SUPPLEMENTARY SERVICE MANUAL

9475LS/LSB

FM/LW/MW/SW 4-BAND
STEREO RADIO
CASSETTE RECORDER

Notice:
The component parts of cassette mechanism have been changed in the midway of production.

Wiring Connection

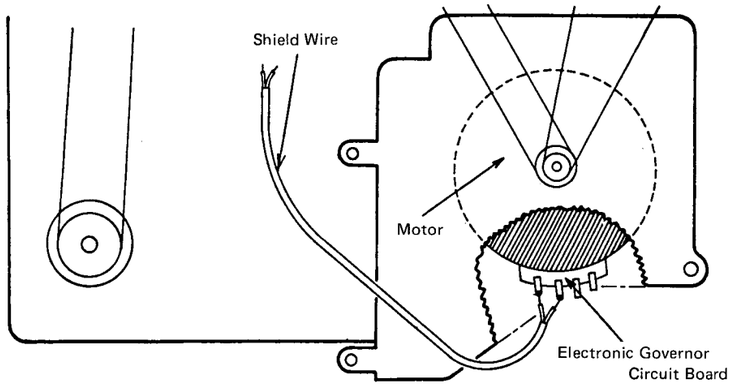
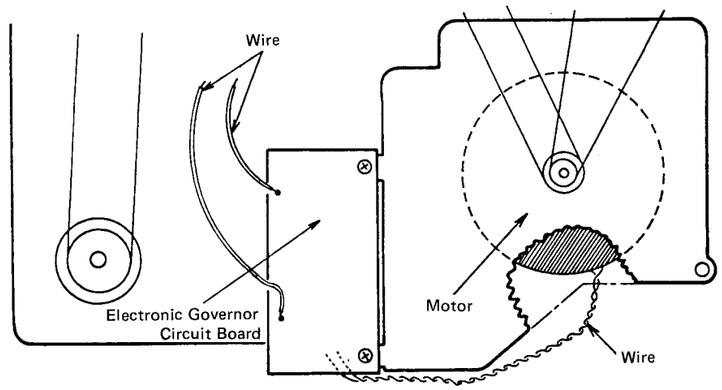
Note: As the electronic governor circuit has been built in the motor housing, the wiring to the motor has been changed.

New

Former

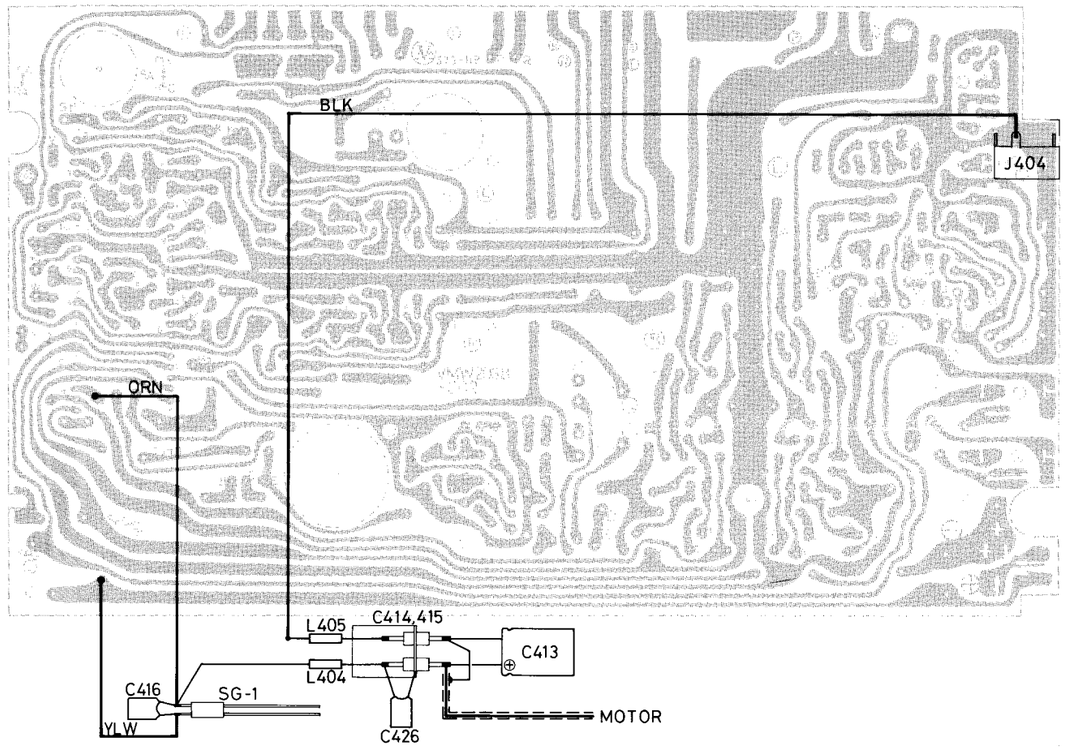
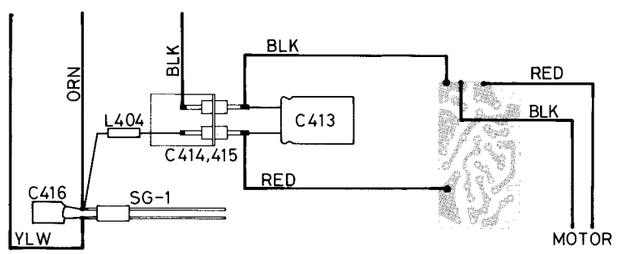
New

Former
